#### **AGENDA MEMORANDUM**

Planning Commission Meeting of January 6, 2021

#### Padre Island-CC Section E, Block 2, Lot 19R (Final)

Request for a Plat Waiver of the Sidewalk Construction Requirements in Section 8.1.4 and 8.2.2 of the Unified Development Code

## Exhibit A

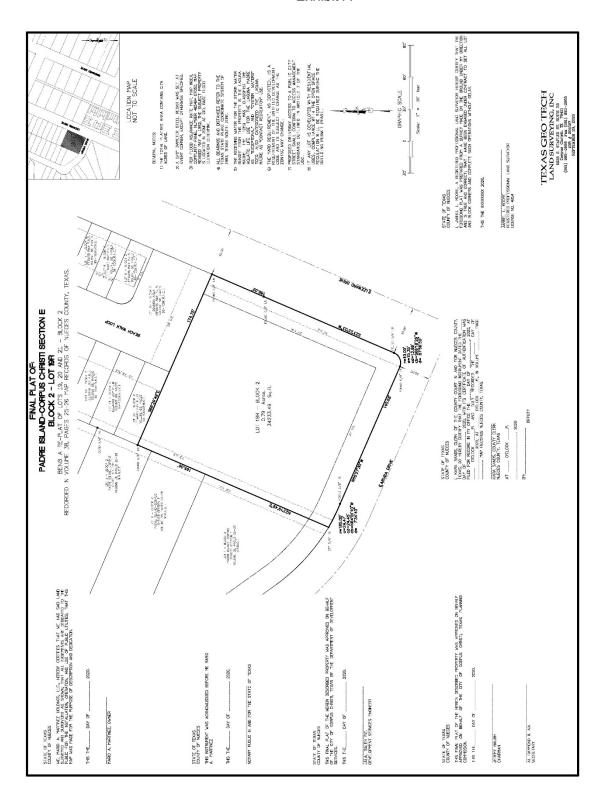
None of the enumerated conditions in UDC 8.2.2.B.1-4 for a sidewalk waiver exist on this subject property.

- 1. The property is in the "CR-2" Resort Commercial District and is a corner lot from which a street and sidewalk network can be continued.
- 2. Resort Commercial Districts emphasis is placed on establishing scenic and/or pedestrian

- 3. The property is 0.30 miles from beach public access.
- 4. Leeward Drive is a Collector Street on the Urban Transportation Plan.
- 5. The Comprehensive Plan, Plan CC, states the community's vision for Transportation and Mobility and calls for connected networks of good streets and sidewalks and safe bicycle routes.
- 6. The Bicycle Mobility Plan shows Leeward Drive as a One-Way Cycle Track (Both Sides) with a Buffered Bike Lane.

Weighing the factors, Staff recommends denial of the waiver from the sidewalk construction requirement.
